6.2 Containment Systems

The information in this section of the reference ABWR DCD, including all subsections, tables, and figures, is incorporated by reference with the following departures and supplements.

STD DEP 6.2-2 (Tables 6.2-1 and 6.2-2, Figures 6.2-2, 6.2-3, 6.2-4, 6.2-5, 6.2-6a and b, 6.2-7a and b, 6.2-8a, 6.2-8b, 6.2-8c, 6.2-9, 6.2-10, 6.2-11, 6.2-12a and 6.2-12b, 6.2-13a and 6.2-13b, 6.2-14, 6.2-15, 6.2-22, 6.2-23a, 6.2-23b, 6.2-24, 6.2-25a, and 6.2-25b.)

Figure 6.2-3 Feedwater Line Break Flow—Feedwater System Side of Break

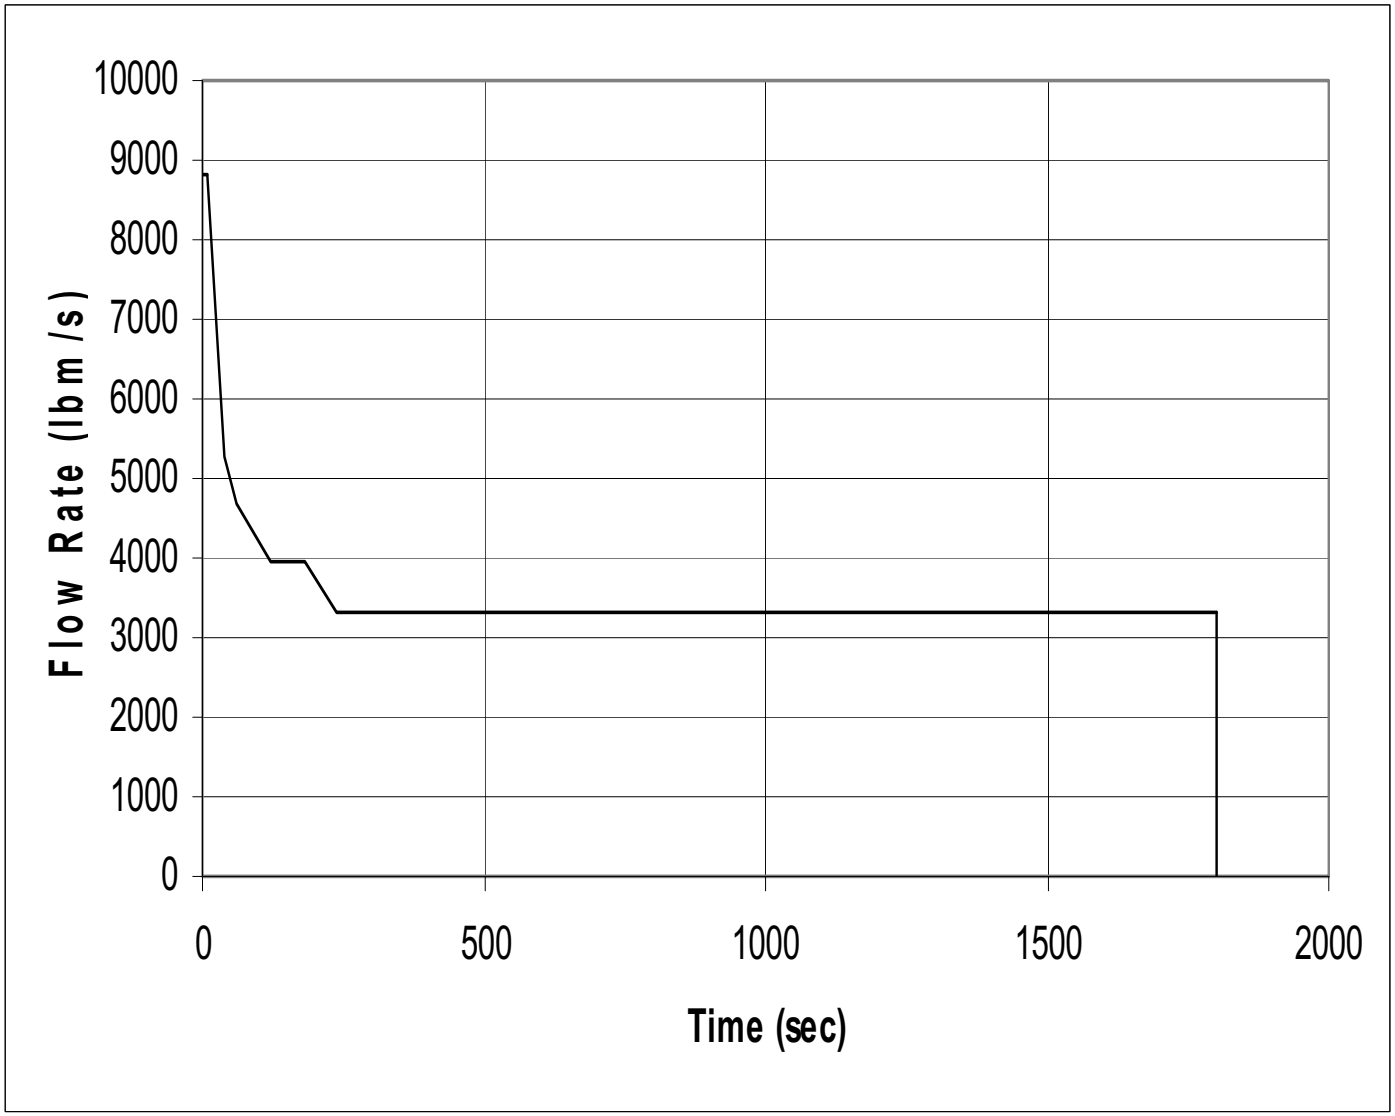
In order to provide further assurance of conservatism, FWLB mitigation is added to the ABWR design. The system is described in Section 7.3.1.1.2. *The specific enthalpy time history, assuming the break flow of Figure 6.2-3, is shown in Figure 6.2-4.* Initial reactor power is assumed to be 102% NBR.

Figure 6.2-6a Drywell Pressure Response for Feedwater Line Break

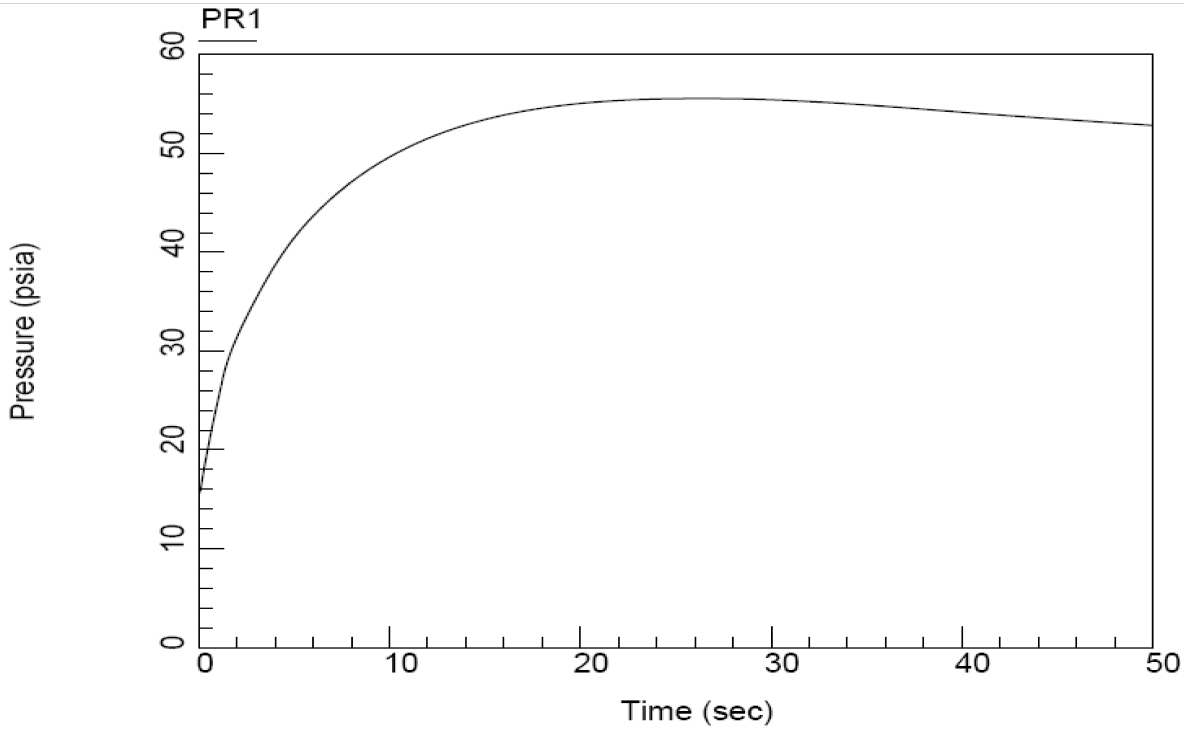
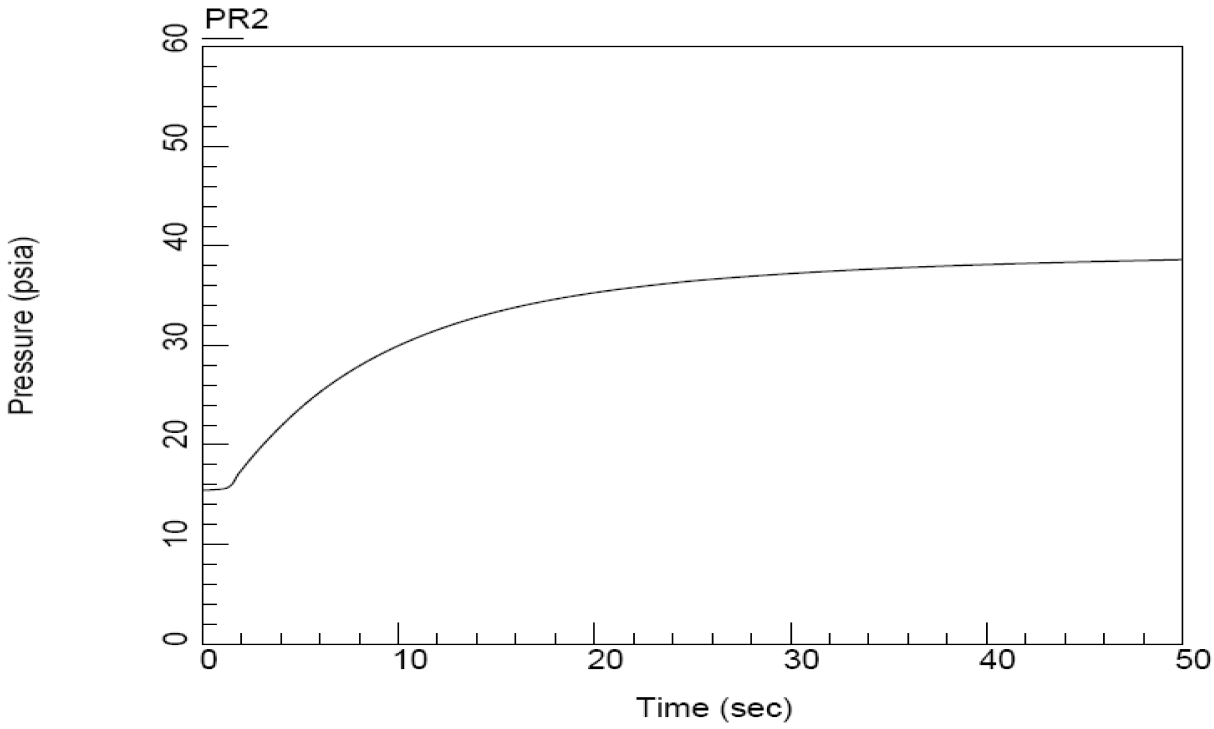
The maximum drywell pressure occurs in the *case of a feedwater line break (~~268.7~~*281.8 *kPaG). The design pressure for the drywell (309.9 kPaG) includes ~~16%~~*approximately 10% *margin.*

The calculated containment pressure and temperature responses for a feedwater line break are shown in Figures 6.2-6 and 6.2-7, respectively. ~~The peak pressure (268.7 kPaG) and temperature (140°C) occur in the drywell. The containment design pressure of 309.9 kPaG is 115% of the peak pressure.~~

Figure 6.2-8a Drywell Temperature Time History After a Feedwater Line Break

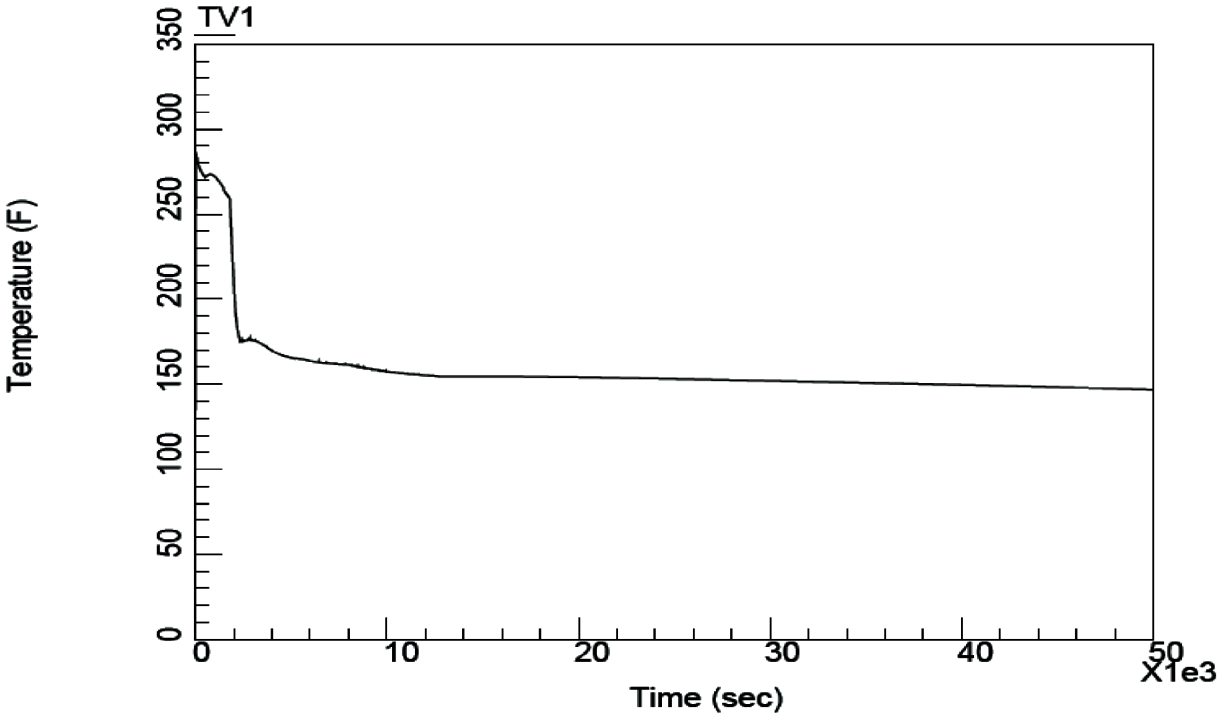
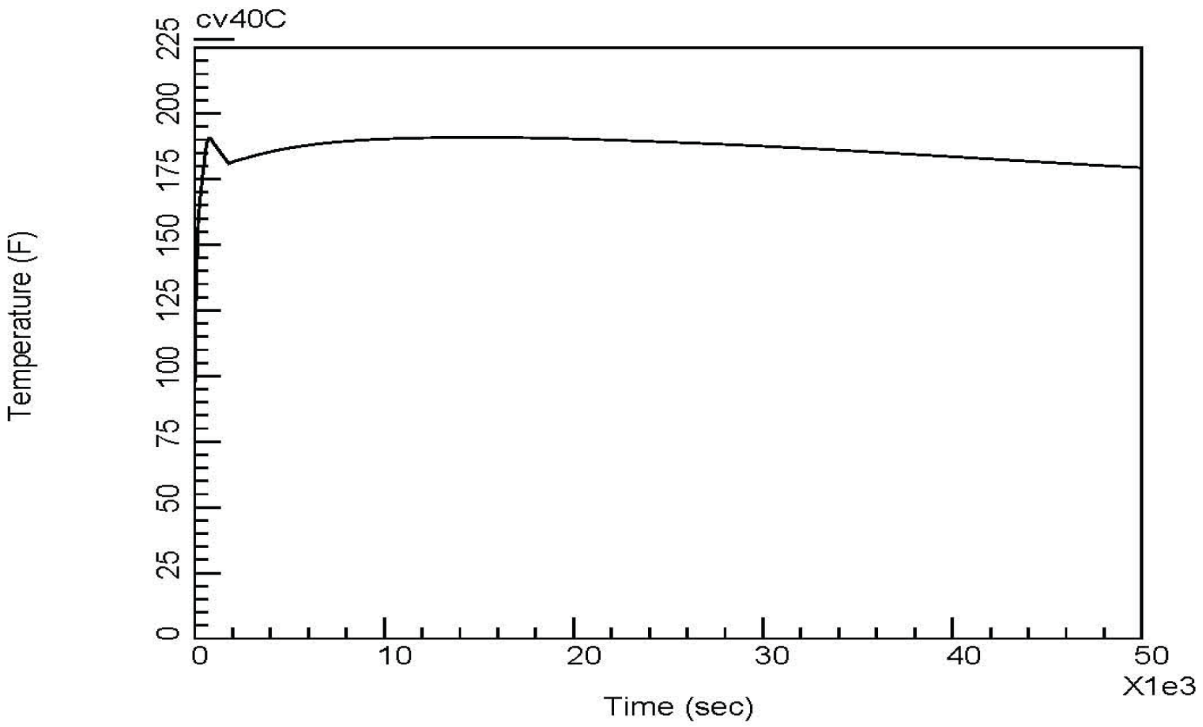
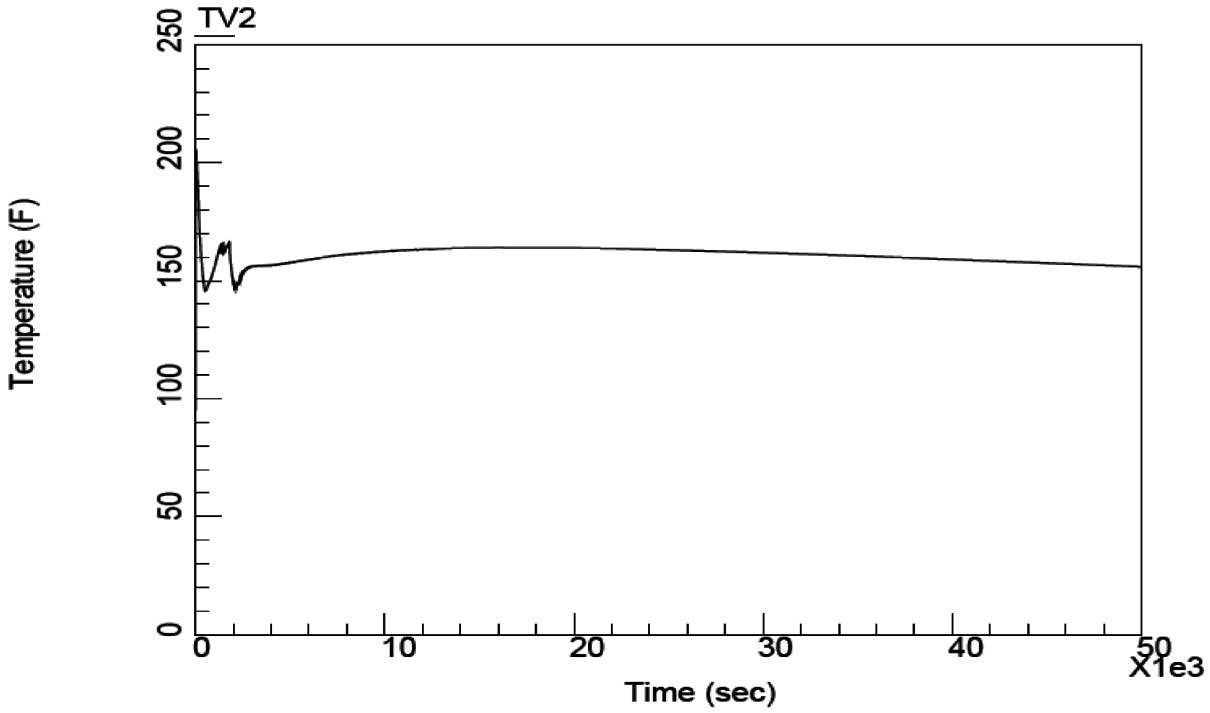
~~*The short term pressure peak (268.7 kPaG) of Figure 6.2-6 is the peak pressure for the whole transient.*~~ *Figure 6.2-8 shows temperature time histories for the suppression pool, wetwell, and drywell temperatures. The peak pool temperature (* 99.6~~5~~*°C) is reached at* 6600 *seconds (*1.833 *hours).* This is less than the suppression pool temperature value of 100°C which is used in the net positive suction head available (NPSHA) calculations.

Figure 6.2-9 ABWR Main Steamlines with a Break

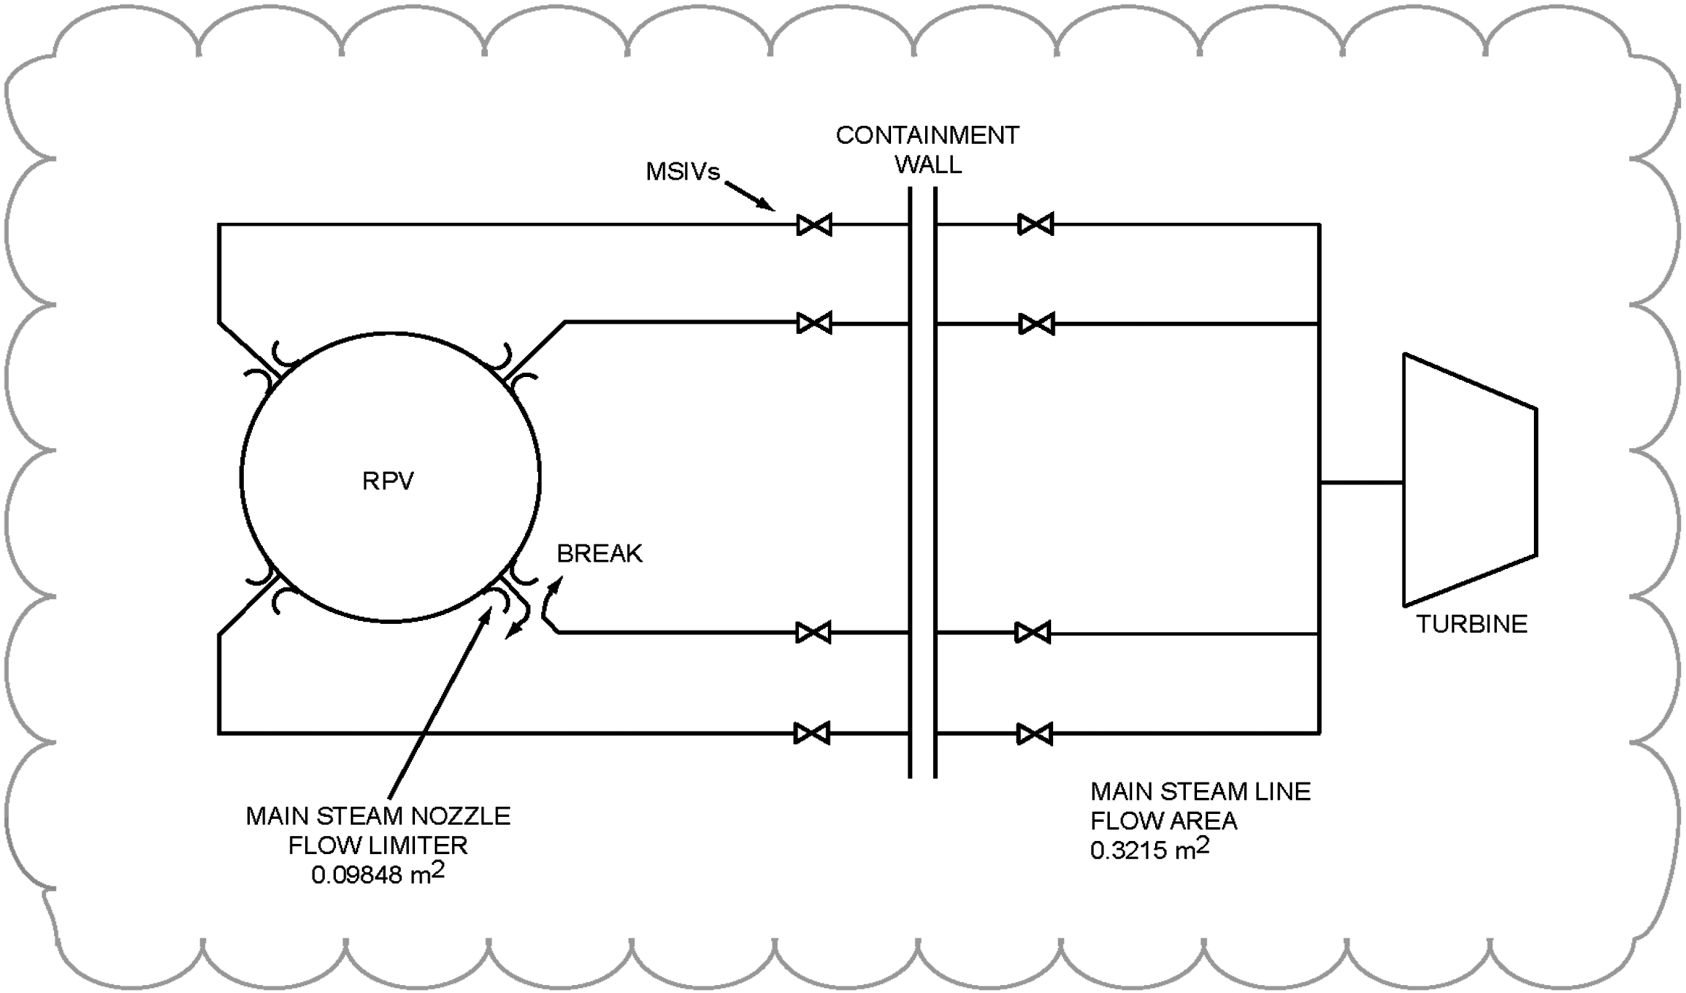
A schematic of the ABWR main steamlines, with a postulated break in one of the main steamlines, is shown in Figure 6.2-9. The main steamline (MSL) break is a double-ended break with one end fed by the RPV directly through the broken line, and the other fed by the RPV through the unbroken main steamlines until the MSIVs are closed. Once the MSIVs are closed, the break flow is only from the RPV through the broken line.

Each MSL contains a flow limiter built into the MSL nozzle on the RPV with a throat area of 0.09848 m^2, as shown in Figure 6.2-9. This flow limiter provides the effective break area for the vessel side.
